## **Manufacturing Notice**

Name:	<b>Plating New Installation Rims</b>
-------	--------------------------------------

Affected Parts:	<b>All two piece "New Installation" Custom Cupholder Company top appearance rims.</b>
Part Name:	<b>Top Appearance Rim</b>

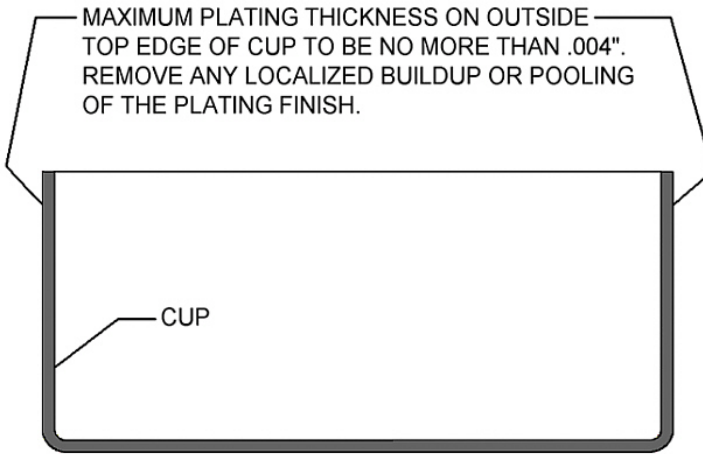
Notice:	<p style="text-align: center;"><b><u>IMPORTANT PLATING INFORMATION</u></b></p>  <p style="text-align: center;">X-SECTION OF RIM SHOWN</p> <p style="text-align: center;">RIM</p> <p>MAXIMUM PLATING THICKNESS ON INSIDE OF RIM FLANGE TO BE NO MORE THAN .004". REMOVE ANY LOCALIZED BUILDUP OR POOLING OF PLATING FINISH.</p>
---------	--
